UNITED STATES PATENT AND TRADEMARK OFFICE

| APPLICATION NO. | FILING DATE | FIRST NAMED INVENTOR | ATTORNEY DOCKET NO. | CONFIRMATION NO. |
|-----------------|-------------|----------------------|---------------------|------------------|
| 10/643,406 | 08/19/2003 | Wen Fei Yu | 10541-1850 | 3454 |

| Office Action Summary | Application No. 10/643,406 | Applicant(s) YU, WEN FEI | |

DETAILED ACTION

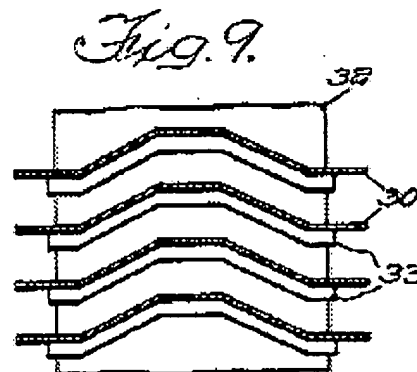
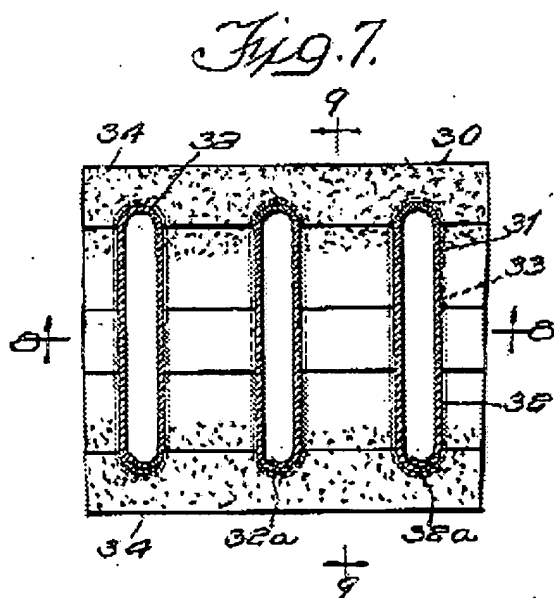
Figure 7 of Modine (1,730,470) discloses a structure having a substantially planar base portion extending laterally (top to bottom) defining a width and longitudinally (left to right) defining a length. Along site line 9-9 of Figure 7, Figure 9 discloses a pair of step portions extending longitudinally along a respective side of the base portion and extending laterally at an angle as a straight segment. The recitation of a "header" does not structurally define over the fins of Modine (1,730,470).

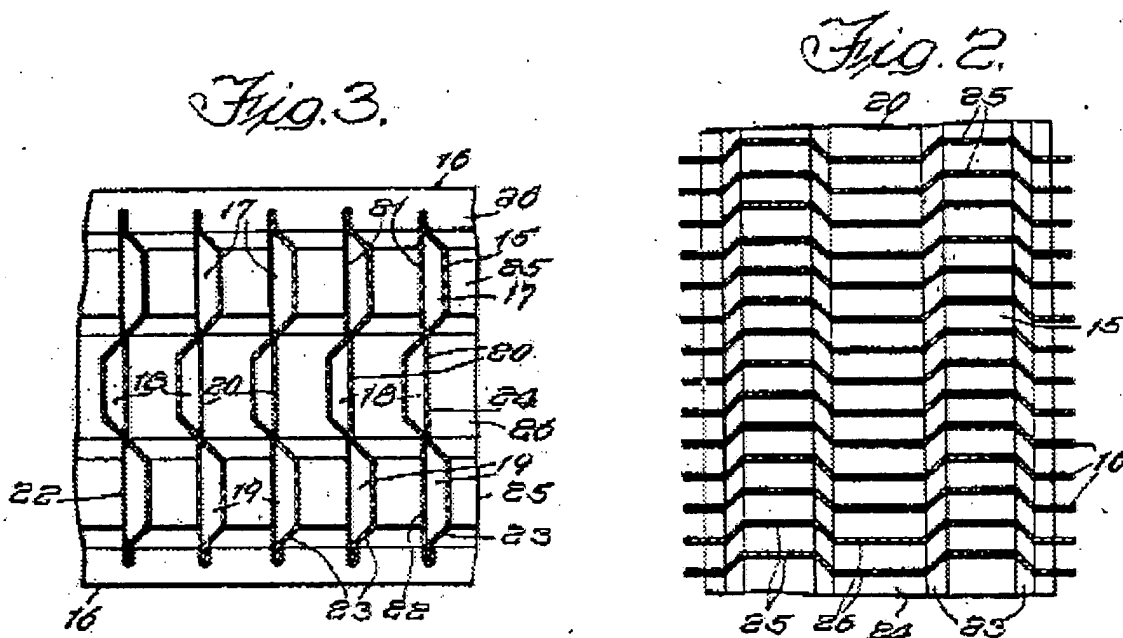
Figure 3 of Modine (1,893,521) discloses a structure having a substantially planar base portion 26 (center) extending laterally (top to bottom) defining a width and longitudinally (left to right) defining a length. In a side view of Figure 3, Figure 2 discloses a pair of step portions (between planar portions 25 and 26) extending longitudinally along a respective side of the base portion 26 (center) and extending laterally at an angle as a straight segment. The recitation of a "header" does not structurally define over the fins of Modine (1,893,521).

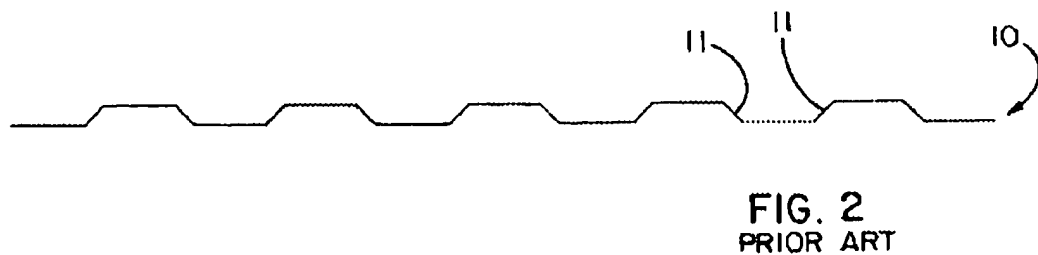
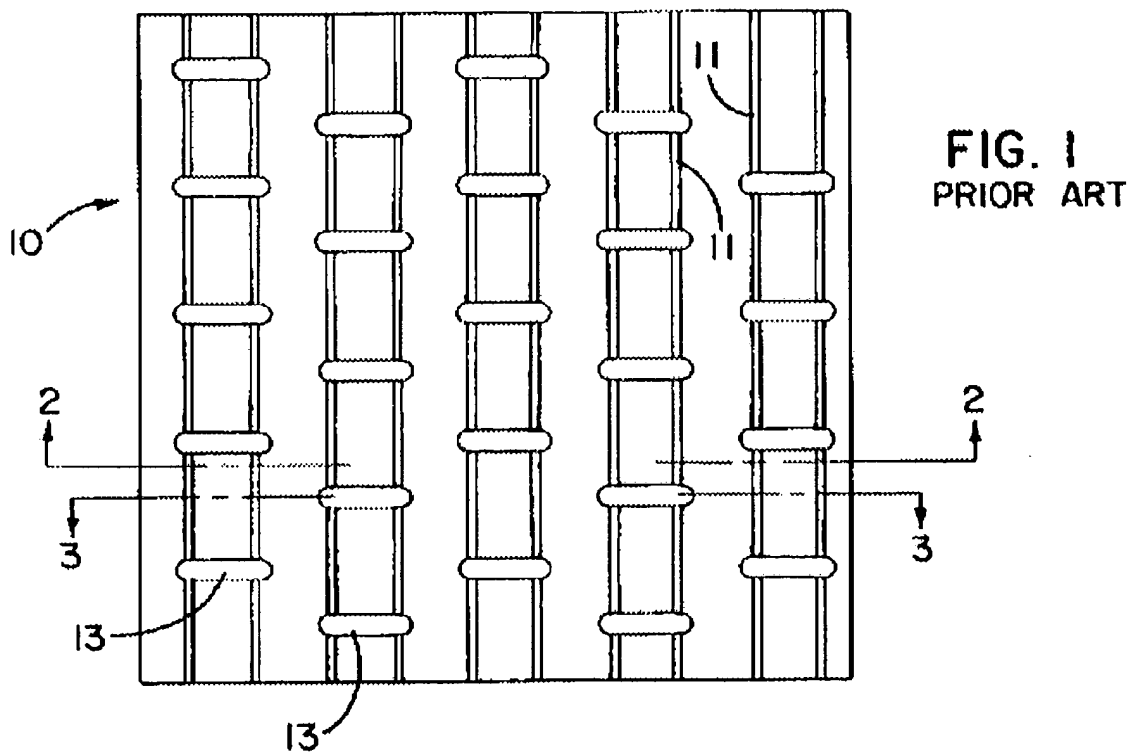
Figure 1 of Hughes et al discloses a structure having a substantially planar base portion extending laterally (left to right) defining a width and longitudinally (top to bottom) defining a length. Along site line 2-2 of Figure 1, Figure 2 discloses a pair of step portions 11 extending longitudinally along a respective side of the base portion and extending laterally at an angle as a straight segment. The recitation of a "header" does not structurally define over the fins of Hughes et al.

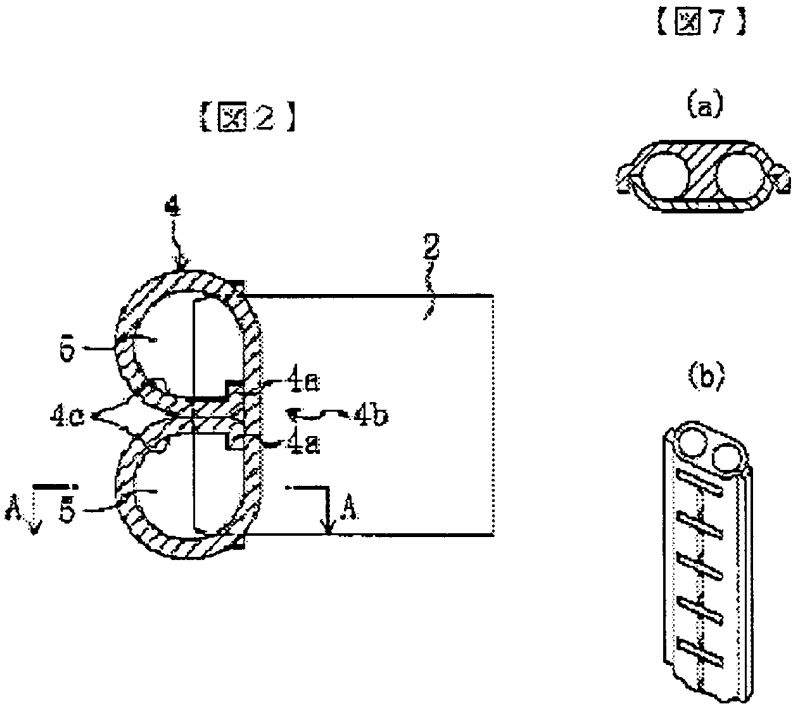
Figure 7a of Yoshida et al discloses a structure having a substantially planar base portion extending laterally (left to right) defining a width and longitudinally (Figure 7b, top to bottom) defining a length. Figure 2 discloses a pair of step portions extending longitudinally along a respective side of the base portion and extending laterally at an angle as a curved segment.

FIG. 22

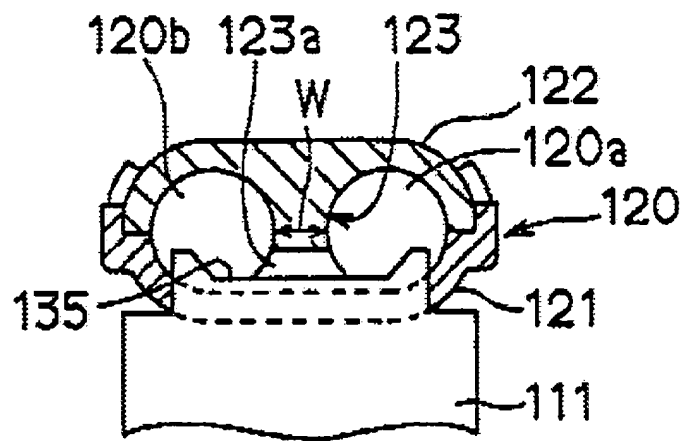
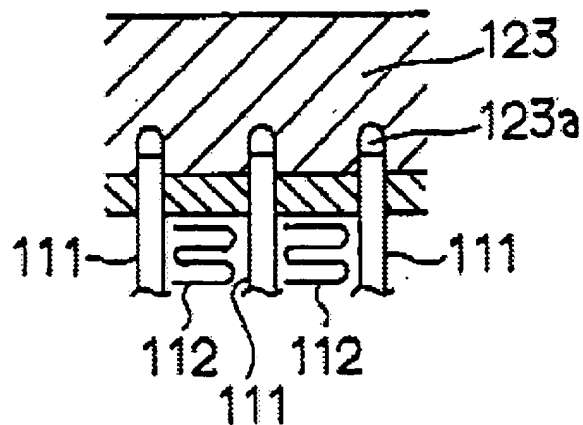
Figure 22 of Kobayashi et al discloses a structure having a substantially planar base portion extending laterally (left to right) defining a width and longitudinally (Figure 23, left to right) defining a length. Figure 22 discloses a pair of step portions extending longitudinally along a respective side of the base portion and extending laterally at an angle as a curved segment.

FIG. 7

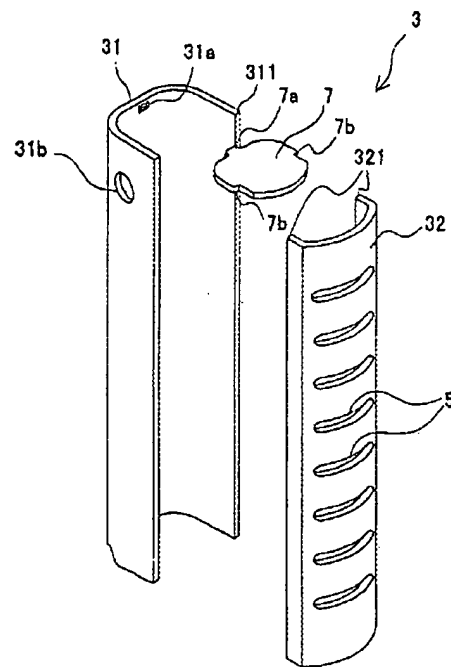
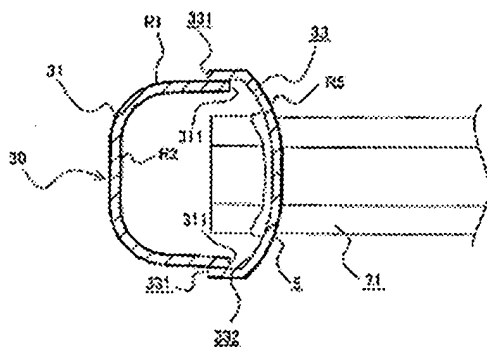
Figure 7 of Kato et al discloses a structure having a substantially planar base portion extending laterally (top to bottom) defining a width and longitudinally (Figure 2, top to bottom) defining a length. Figure 7 discloses a pair of step portions extending longitudinally along a respective side of the base portion and extending laterally at an angle as a curved segment.

FIG. 3

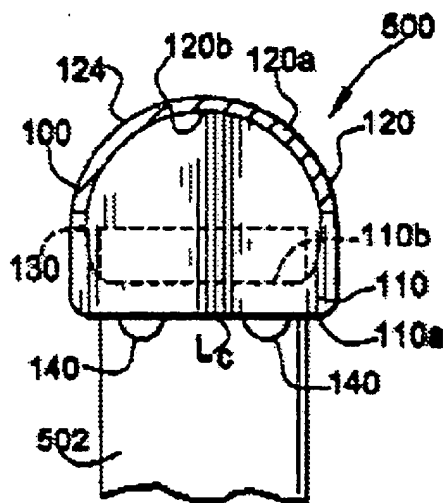
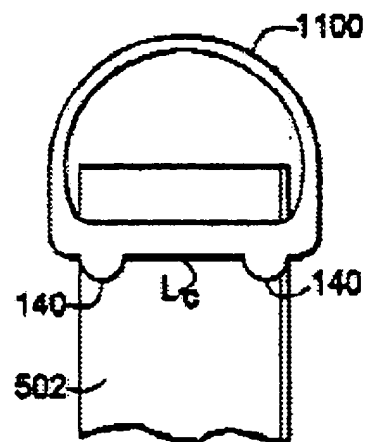
Claims 1-2 and 7-11 are rejected under 35 U.S.C. 102(e) as being anticipated by Gowan et al (Figures 3-4). Regarding claims 9-11, the juncture of Gowan et al inherently meets the claim limitations.
